Planning Application Ref: AW/193/21/T

Location: The Grange, Grange Court, Aldwick, PO21 4XR

Description of works: Crown lift 2no. yew trees (T-222 & T-223) to approx. 2.5m above road level

Figure 2 Positions of final cuts

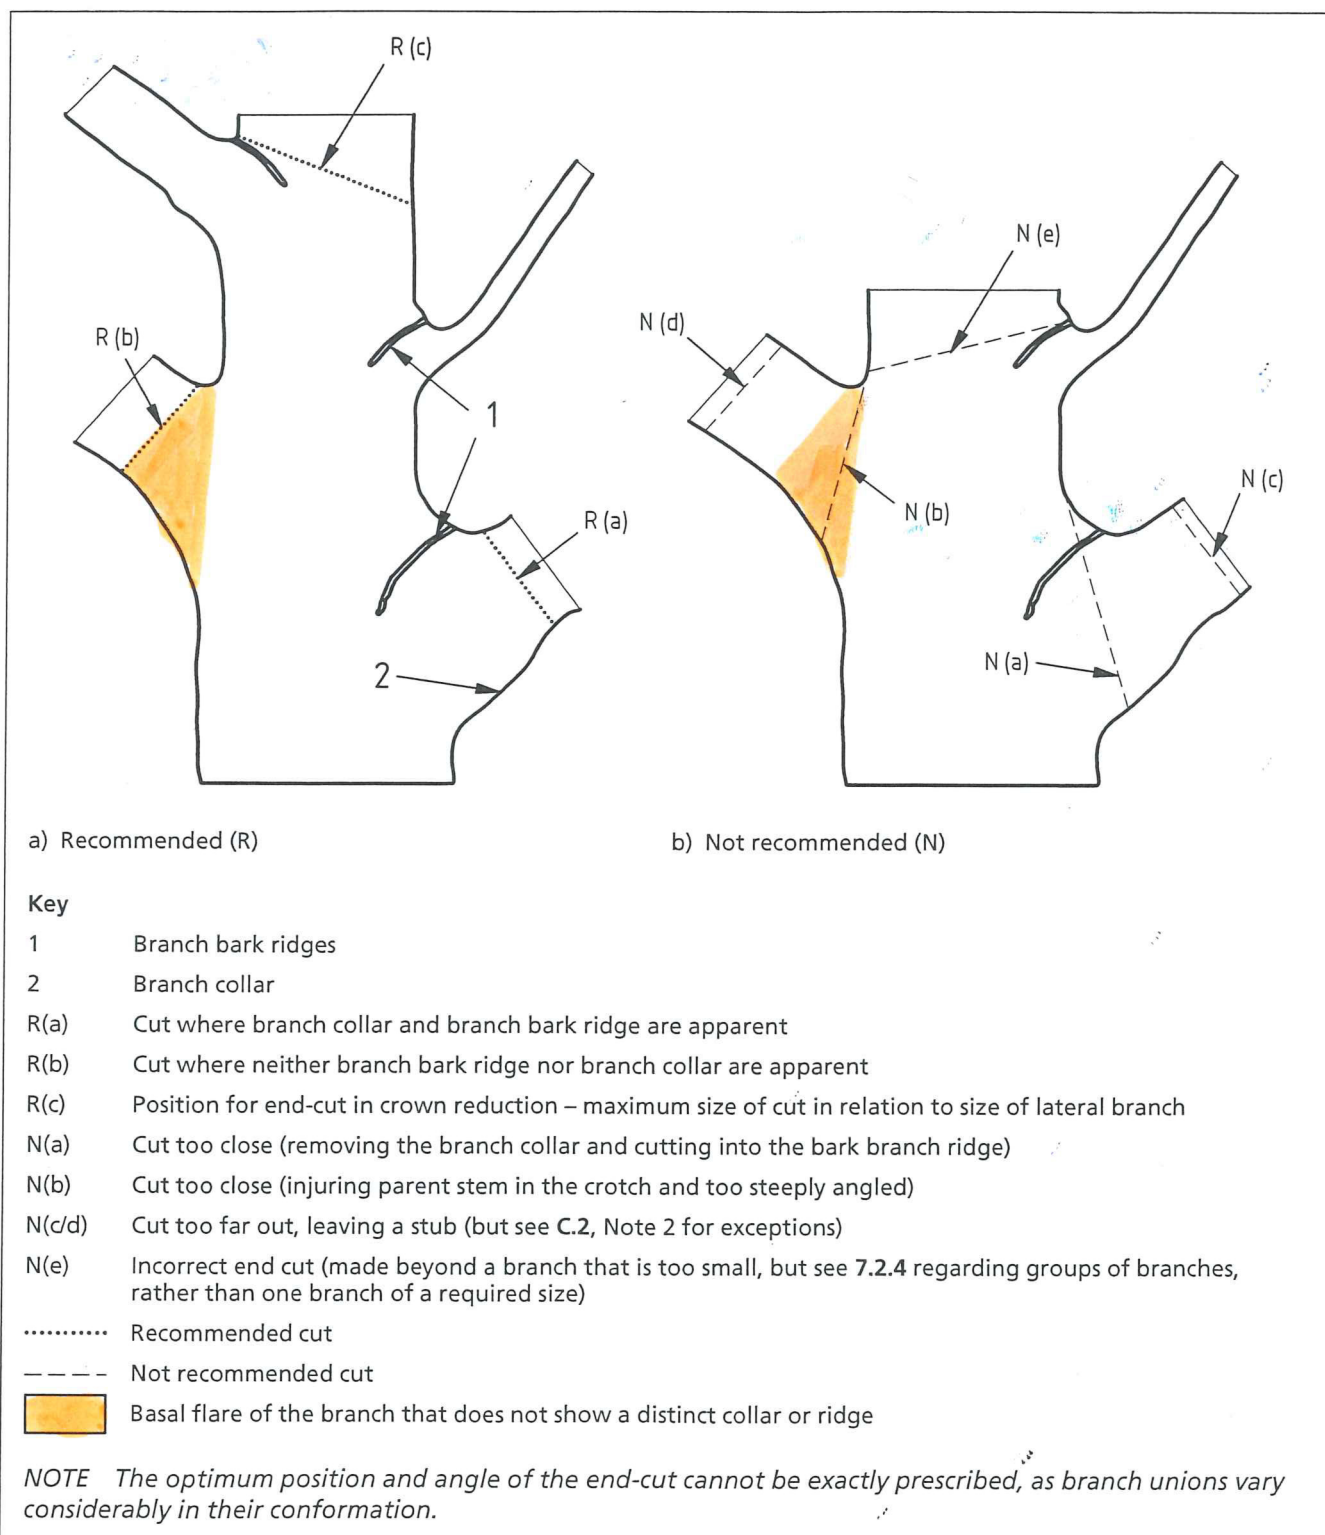
Where whole branches are to be removed and final cuts made close to the trunk or branch union they are to be made as shown in Figure 2 of BS3998:2010.
